ADDENDUM

NO. 3

PROJECT NAME: Lehman High School 2025 Additions and Renovations

ADDENDUM DATE: 14 May, 2025

1 LEVEL 2 FRAMING PLAN - AREA C

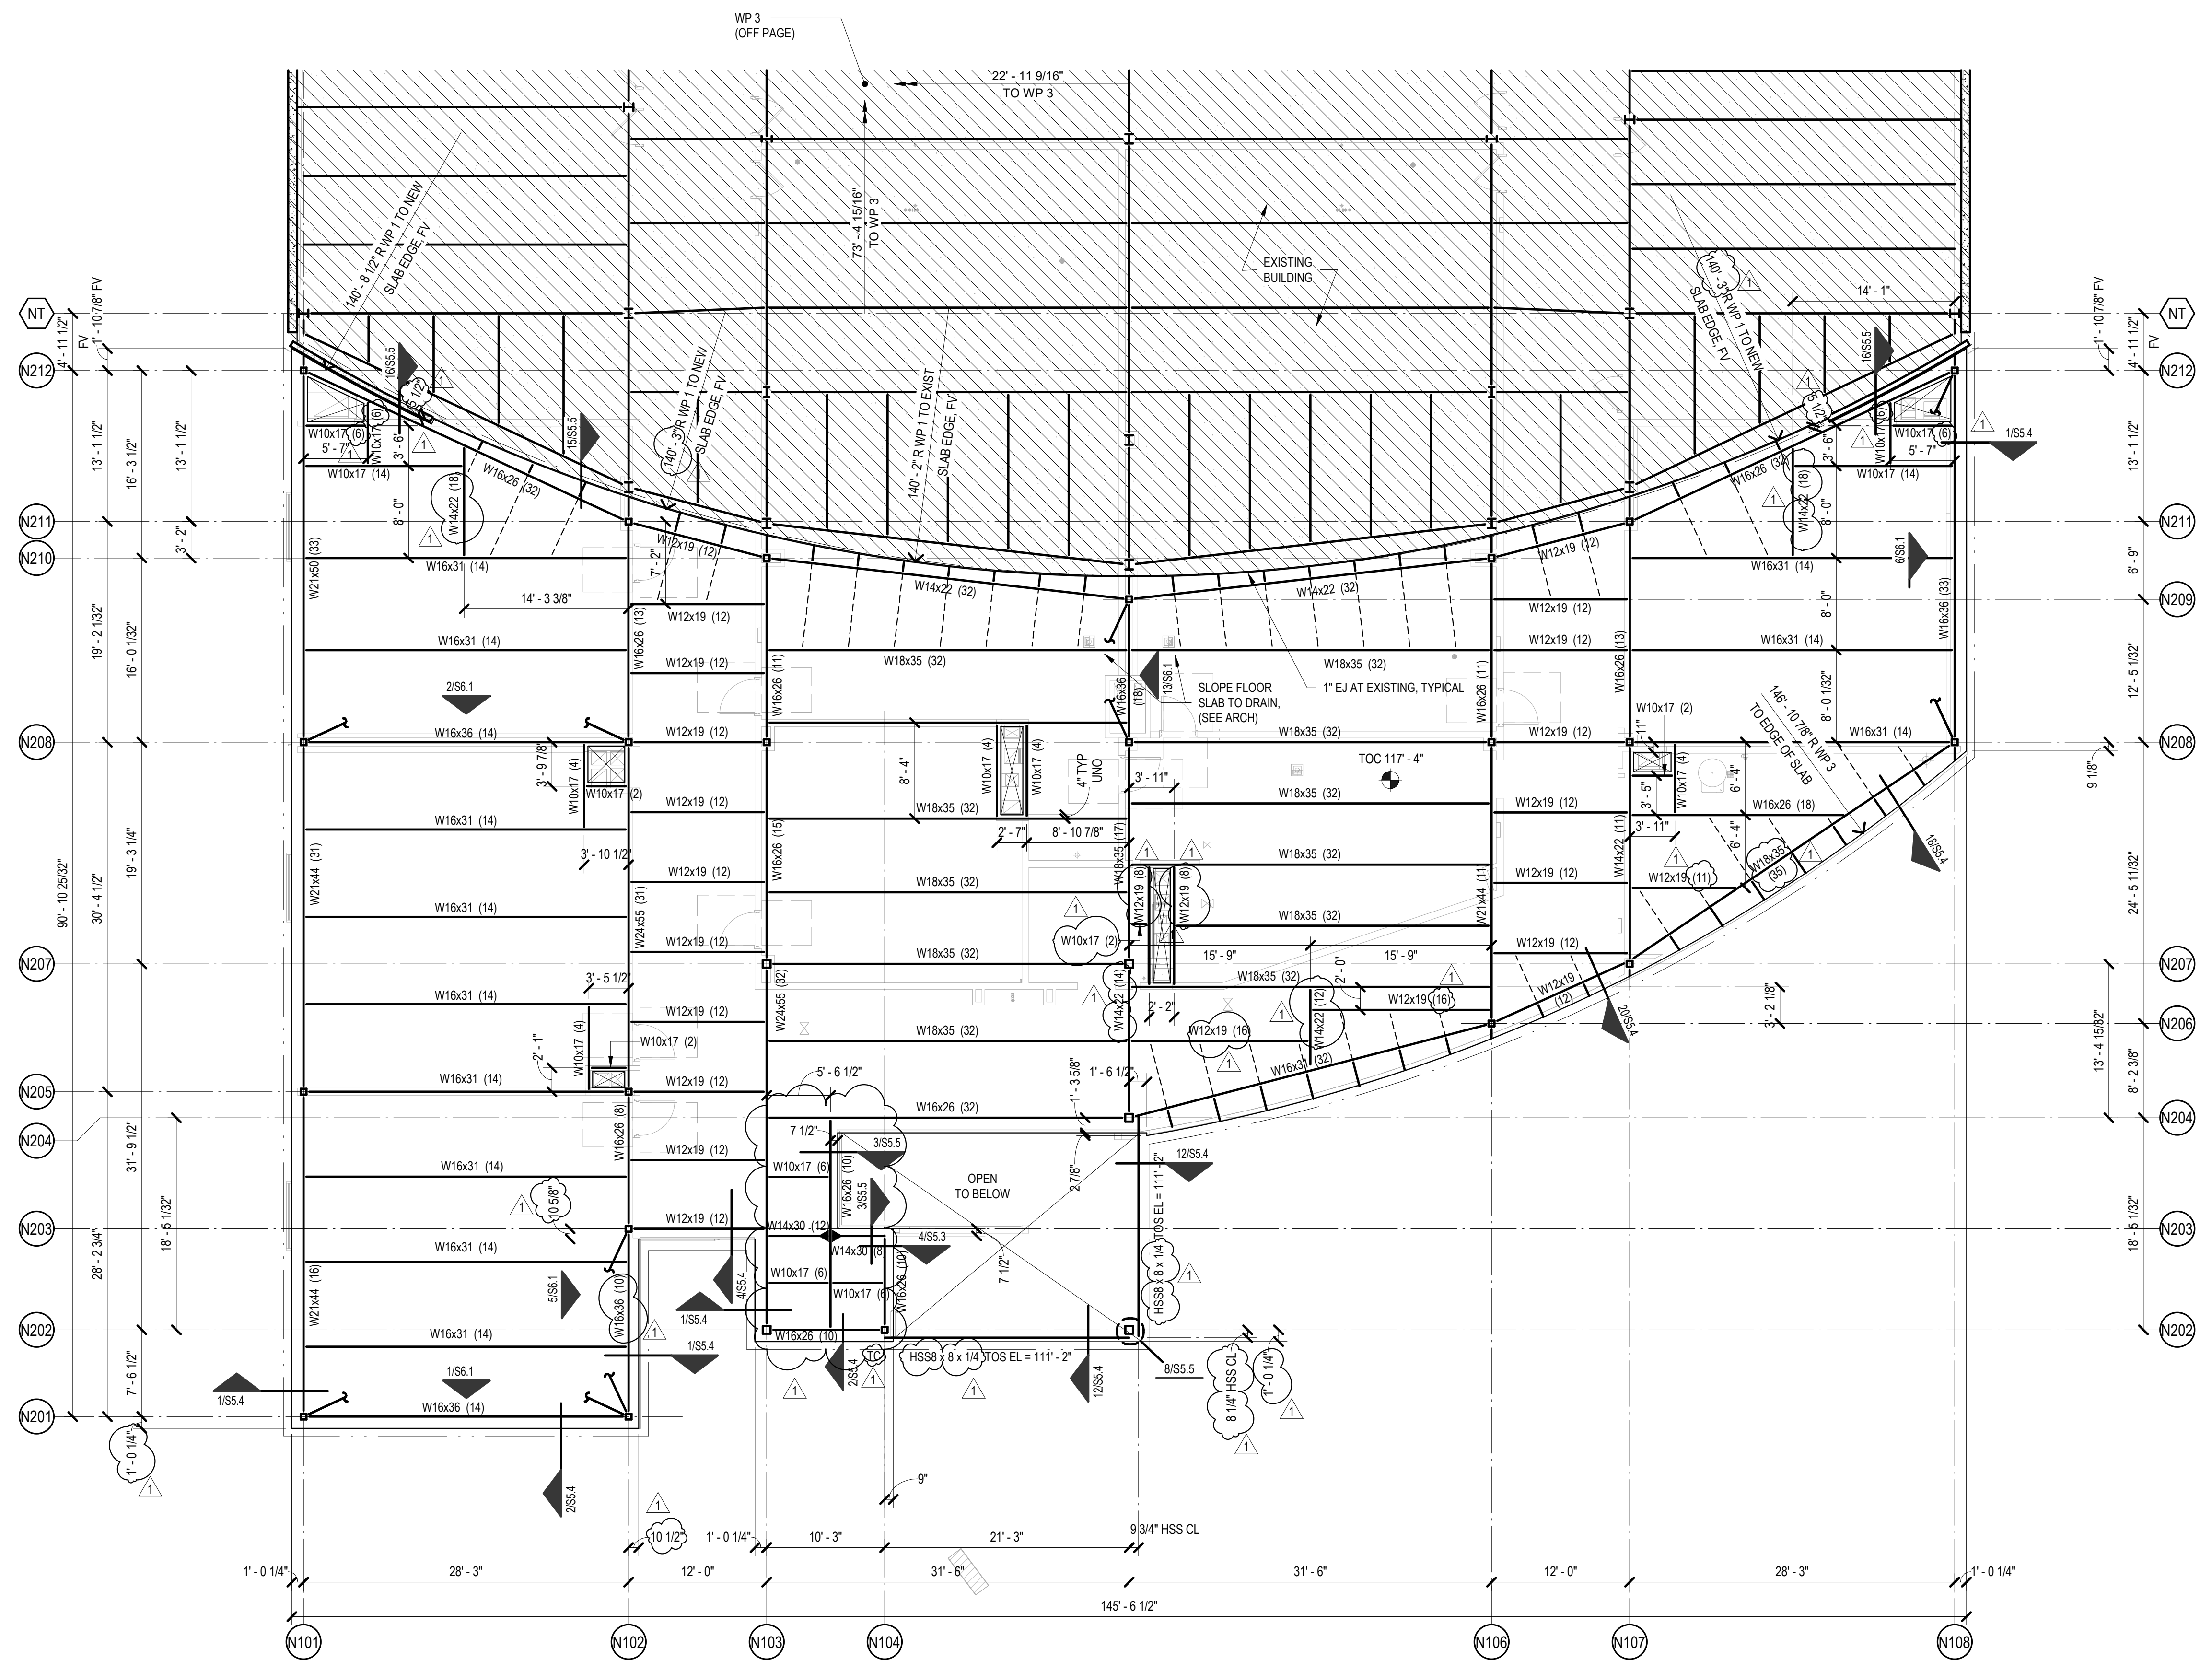
- 1) Update beam sizes where shown.
- 2) Revised dimensions where shown.
- 3) Revised stud count where shown.
- 4) Updated HSS girt sizes where shown.
- 5) Revised slab type for exposed, polished concrete slabs

PACKAGE	VOLUME
b No. 954-08-01 Drawn By: JFP Date: 7/22/2025	Sheet No. ISSUE FOR BID S2.1D1

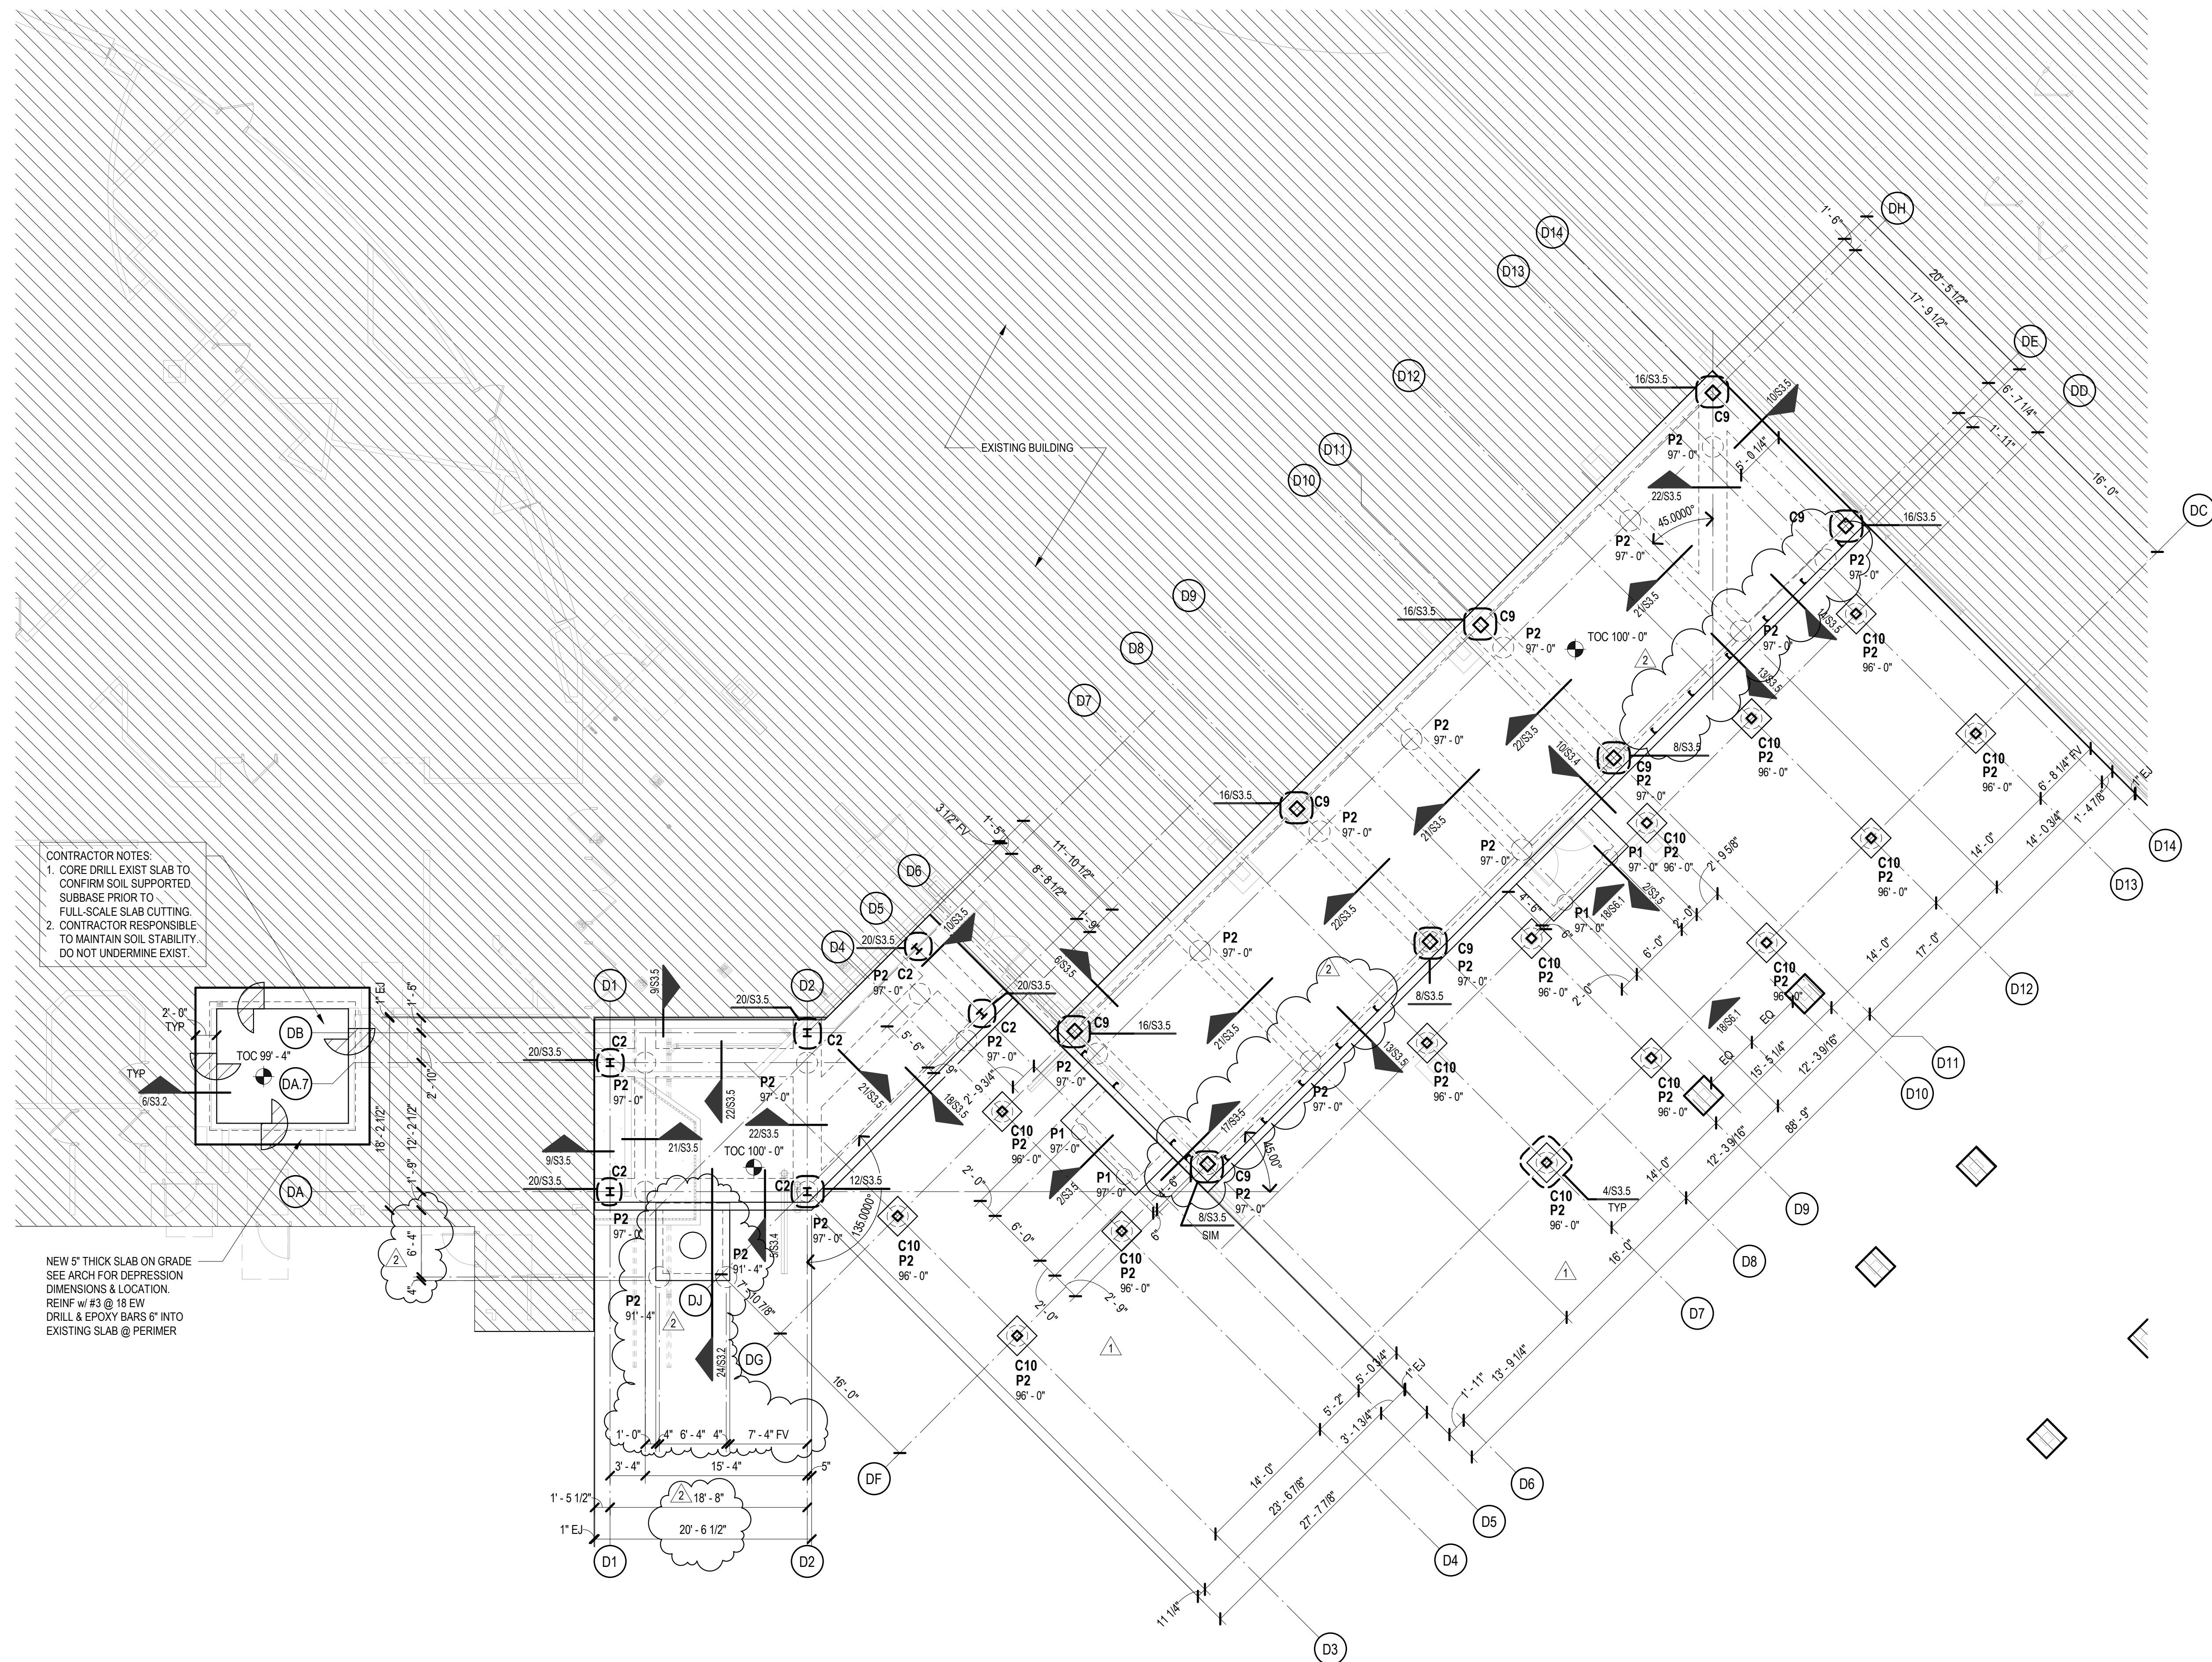
- 1) Channels shown on foundation level.
- 2) Added vault, piers, detail reference, and dimensions for suspended plumbing transition.
- 3) Added and revised dimensions for clarity.

PACKAGE		VOLUME
Job No. 01954-08-01	Sheet No. ISSUE FOR BID	
Drawn By: LAFP	S2.1D2	
Date: 04/22/2025

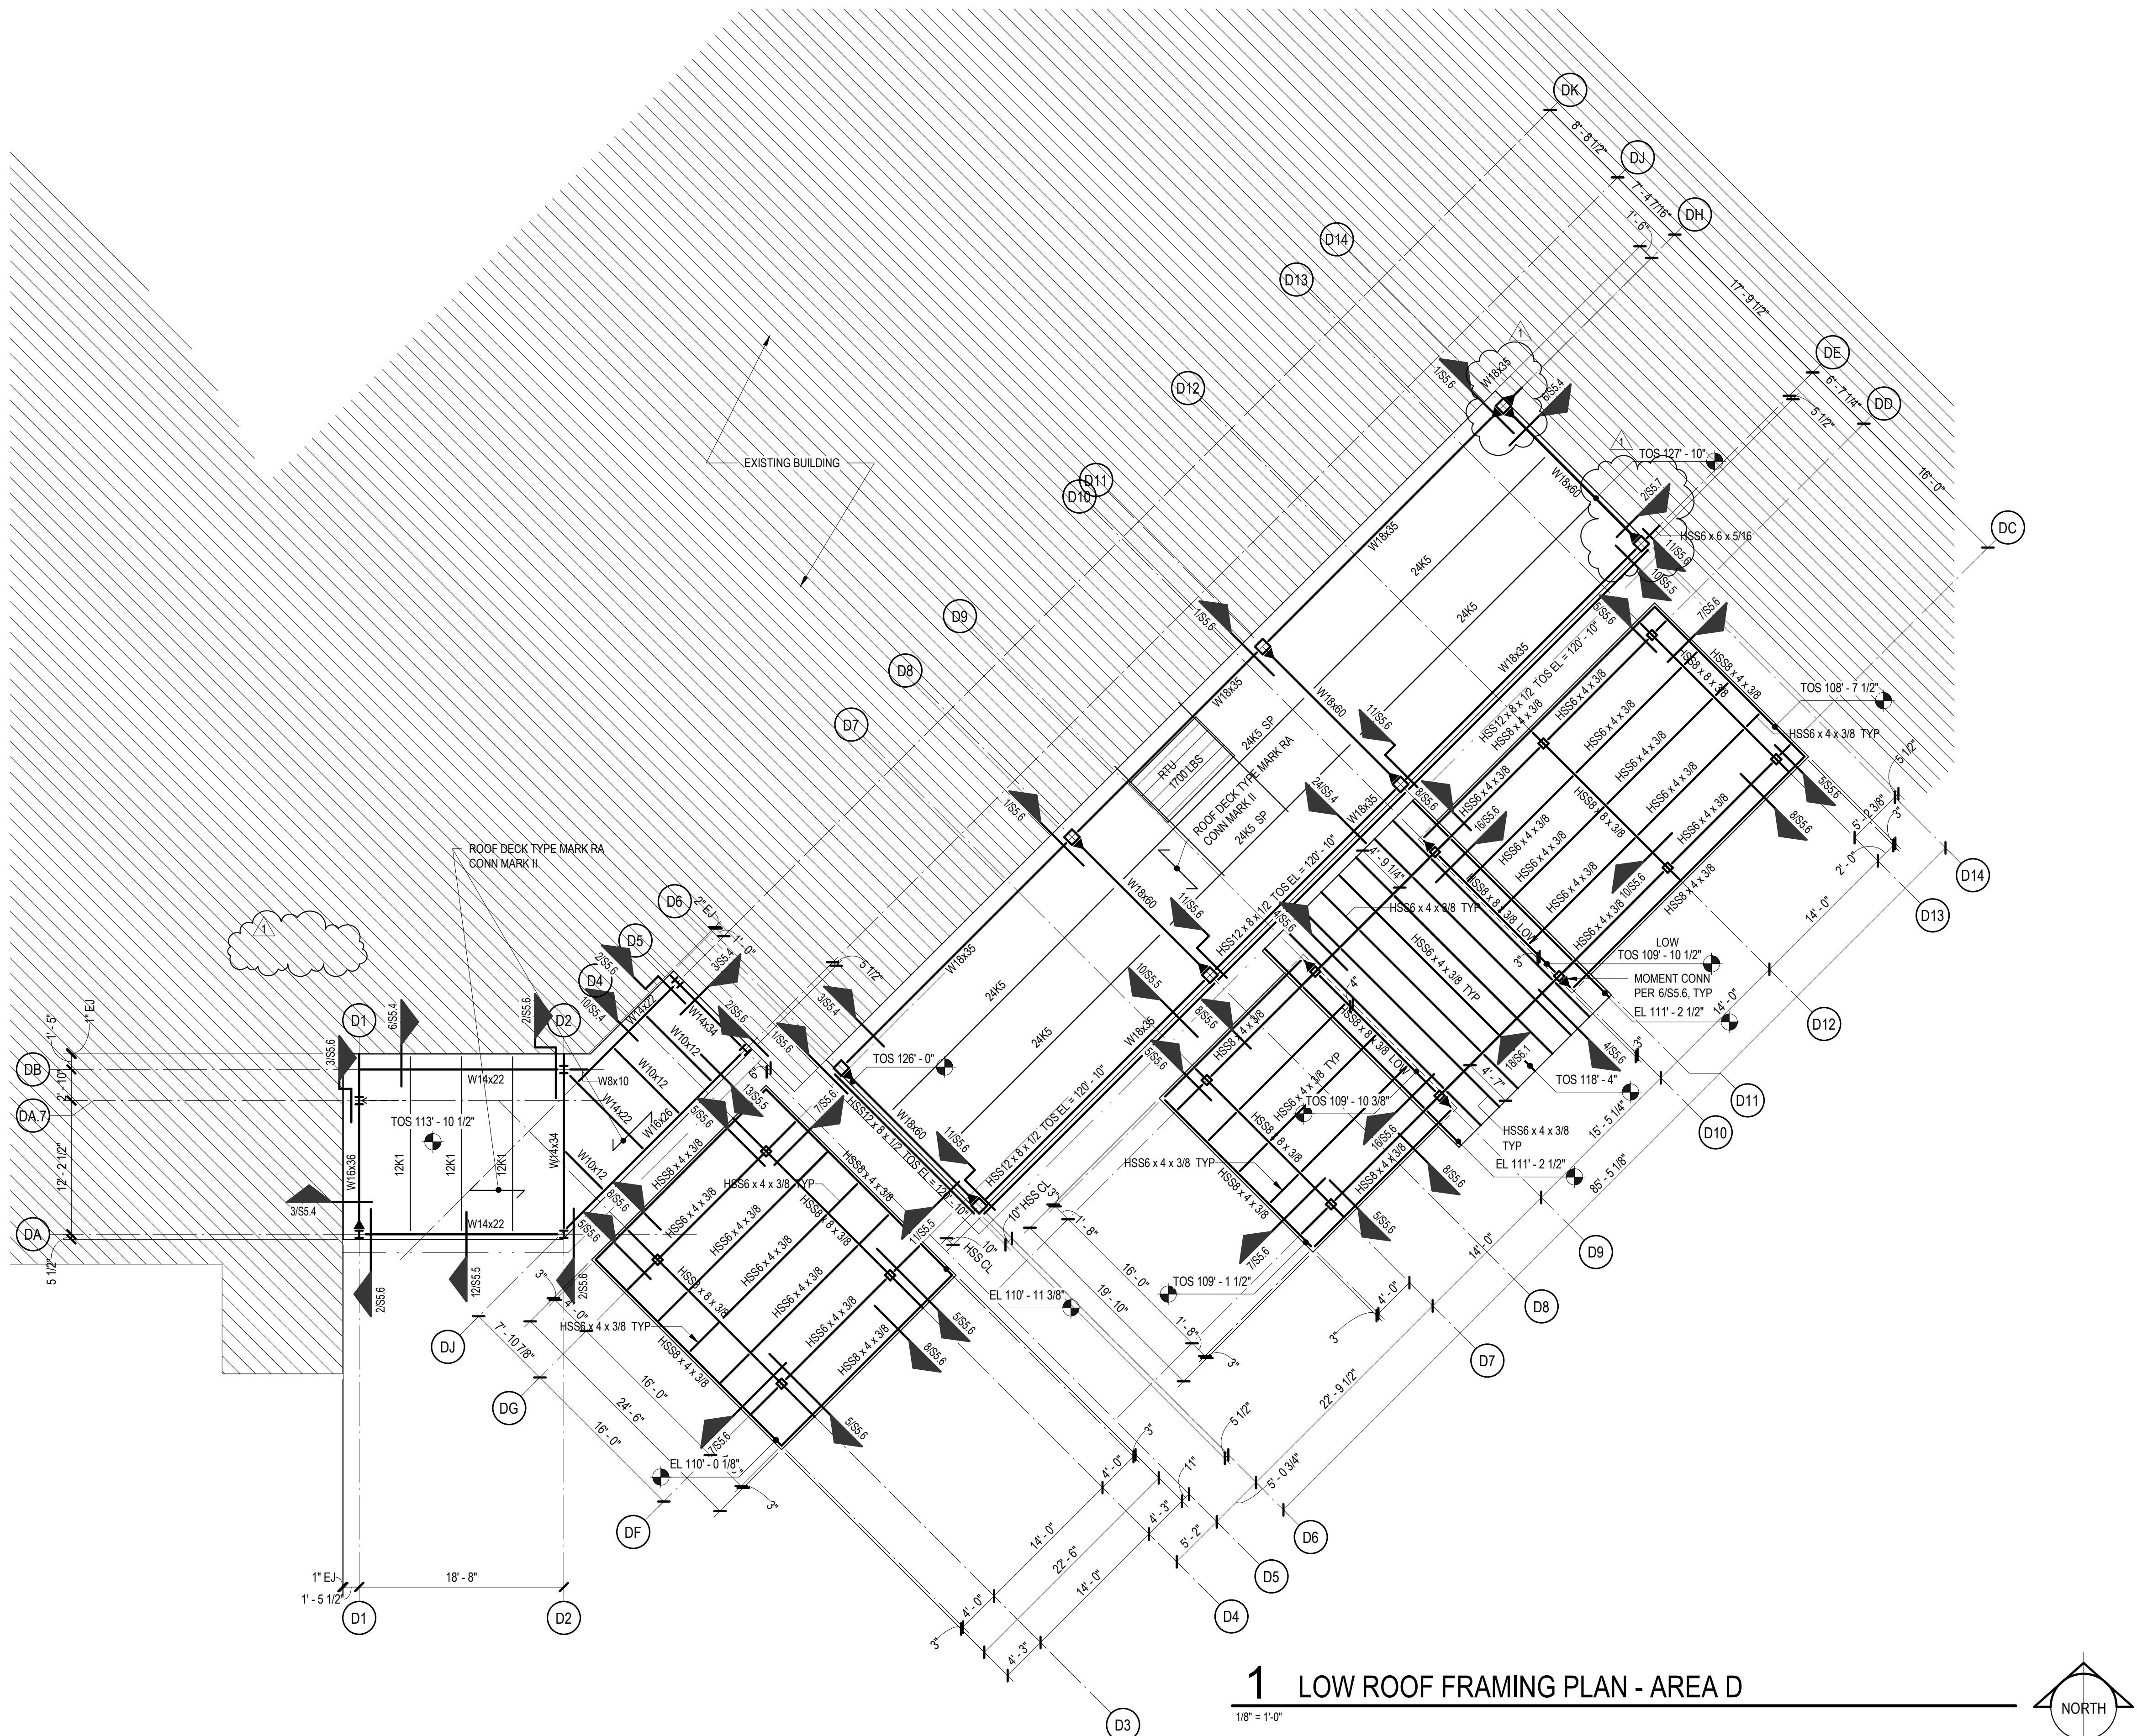
- 1) Cantilevered tube added at D14/DE.
- 2) Cantilevered beam added at D14/DH.
- 3) Removed note regarding EJ size that conflicted with dimensions and model.
- 4) Added and revised dimensions for clarity.
